Customer Services Bulletin 27/03/2020 TB-M-0047 – TB-C-0055

Re: Dometic Fridge Condenser Pipe

Fridge Water Drain Pipe Fixing

Z-SOP-RPC-P-SP-0011

Opp 4 Operation Description:

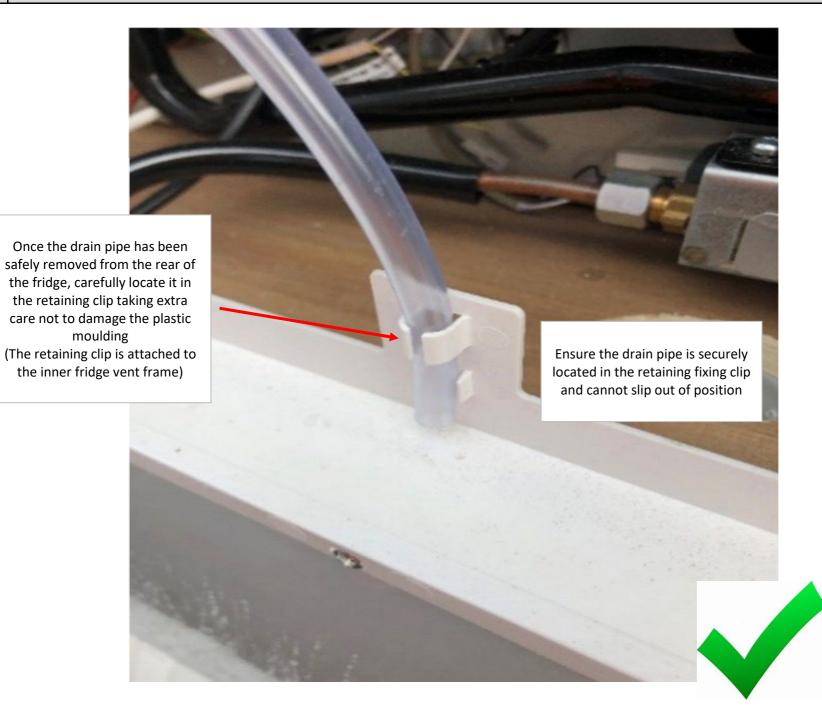
Re-fitting the outer fridge vent cover: Insert fridge vent Right Hand Side first, ensure the top cover engages with X2 clips on Right Hand Side of frame.

Once the right hand side of the cover is fully located, carefully push the left hand side of vent in so both sides are fully locked into position/engaged.
